HISTORIC AND DESIGN REVIEW COMMISSION

Agenda Item No: 13

HDRC CASE NO: 2015-283
ADDRESS: 524 N PINE ST
LEGAL DESCRIPTION: NCB 1370 BLK 2 LOT 3
ZONING: RM4 H
CITY COUNCIL DIST.: 2
DISTRICT: Dignowity Hill Historic District
APPLICANT: Ceaser Gonzalez
OWNER: Ceaser Gonzalez
TYPE OF WORK: New construction of single family house
REQUEST:

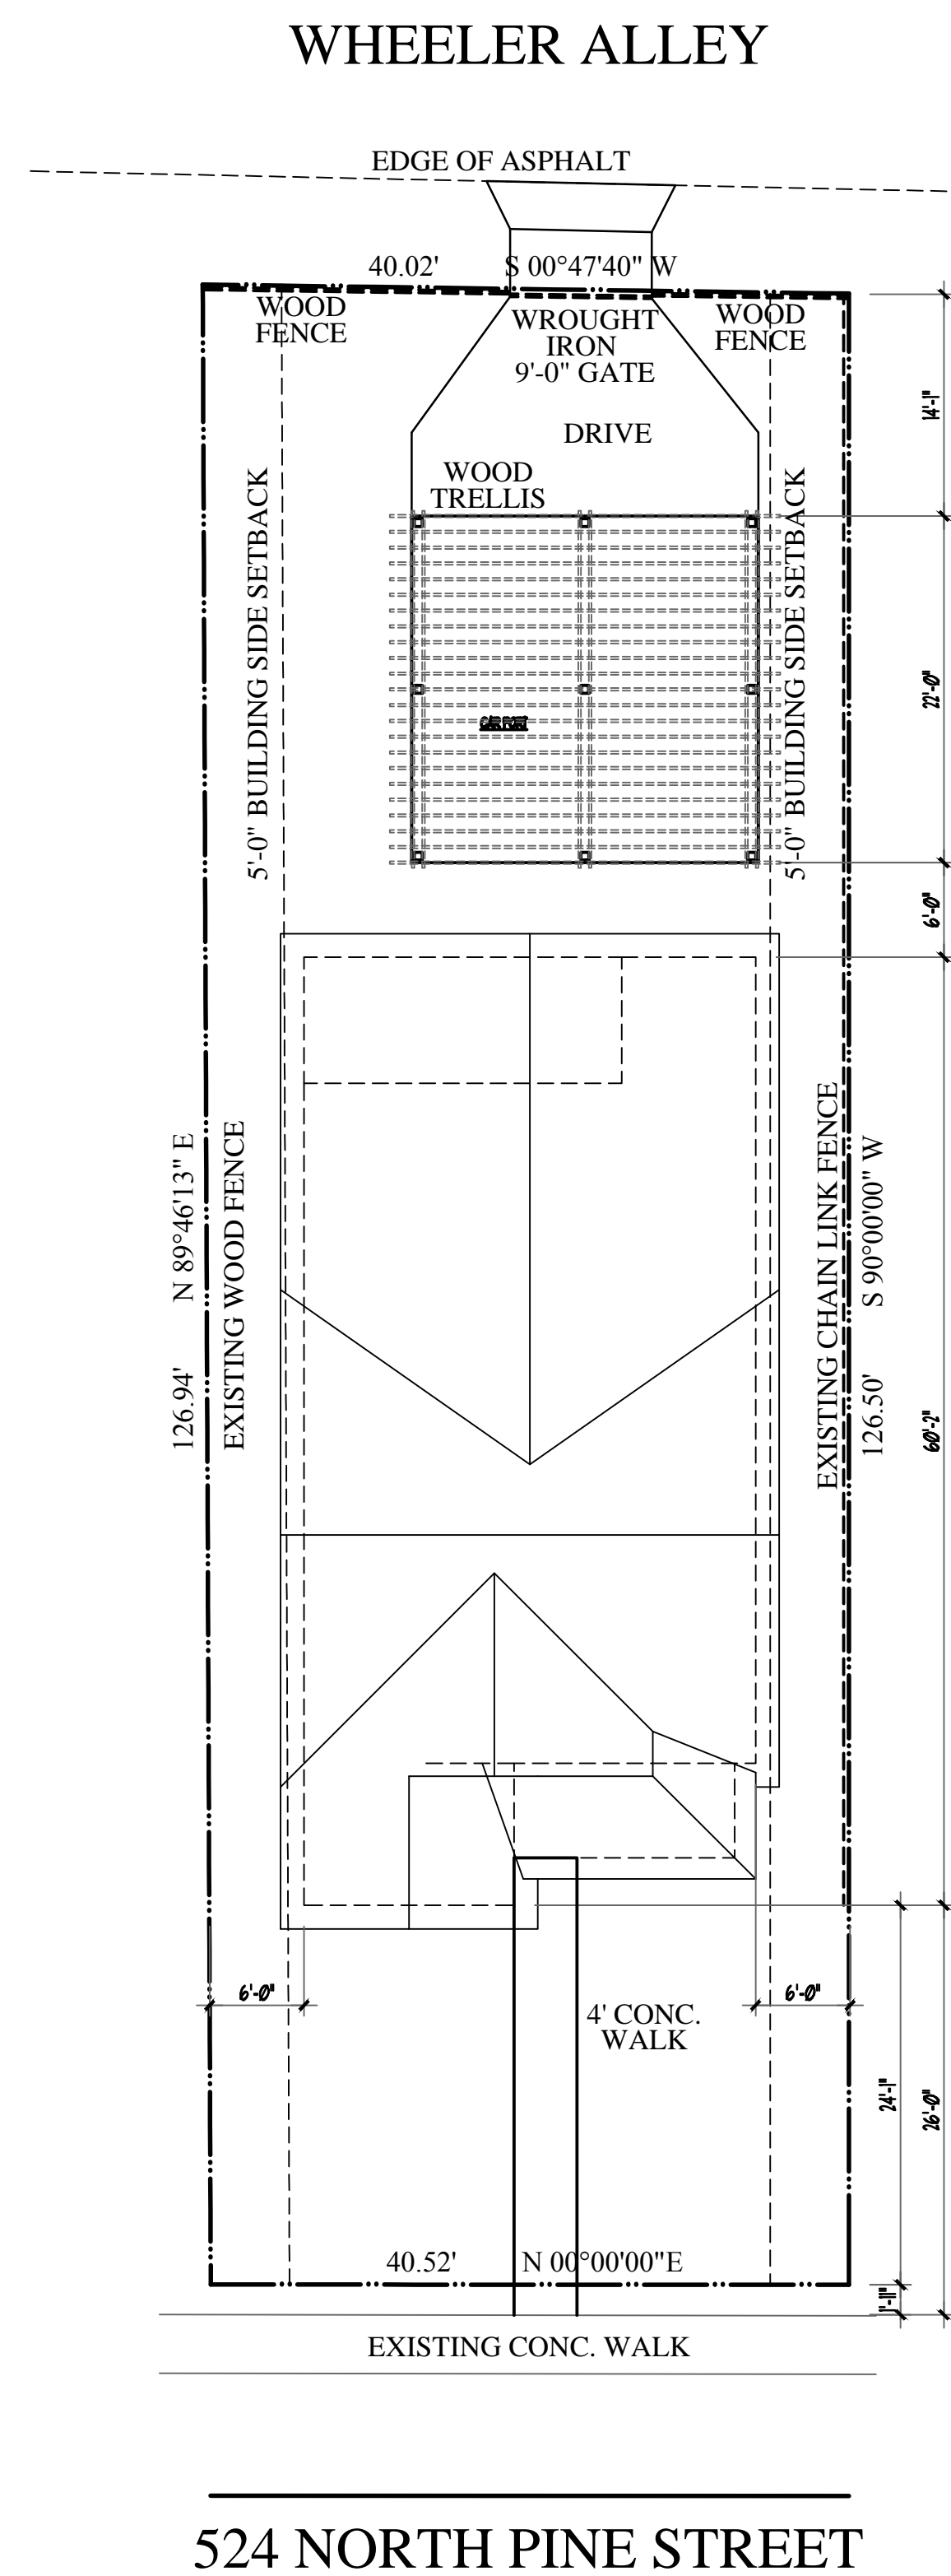
- a. The project was reviewed by the Design Review Committee on July 7, 2015, at that time the Committee recommended the applicant submit additional information on the context, revise the detail for the return at the front gable overhang, and revise side and rear fenestration and window sizes to make it more consistent.

- d. As recommended by the Guidelines for New Construction, new roof forms should be consistent with those predominantly found on the block in pitch, overhangs, and orientation. The proposed roof is consistent with other historic roofs in pitch, overhangs and orientation. However, the composition of the roof should be revised to have a continuous ridge along the top to match the historic configuration of cross-gable roofs.

- e. Consistent with the Guidelines for New Construction, window and door openings should have a similar proportion of wall to window space as typical nearby historic facades. Windows, doors, porches, entryways, dormers, bays, and pediments shall be considered similar if they are no larger than 25% in size and vary no more than 10% in height to width ratio from adjacent historic facades. The proposed fenestration pattern along the front of the house is consistent with the guidelines, however the fenestration pattern along the sides and rear should be revised to have a rhythm and pattern more consistent with nearby historic facades.

COMMENTS/CONCERNS: CB - intended to do two windows vs. one w/ shutter. MB - If you're doing wood, you should look at doing all wood. BF - having an aerial might help. Show context. MB - Street elevation is appropriate. Detail for return at gable. Bulk of house has lower ridge line. Visibility of side elevation? CB - sides aren't very exposed. MB - Multiplicity of window types, play w/ sizes to make it more consistent. Look at return. Rear elevation isn't an issue. Not visible. Nicely done, good infill design.

- a. The roof is revised to have a continuous ridge along the top
- b. Fenestration pattern along the sides and back is revised to be consistent with adjacent historic facades
- c. The carport aligns as close as possible with adjacent garages
- d. Information on placement of mechanical units, landscaping and fencing is submitted for review
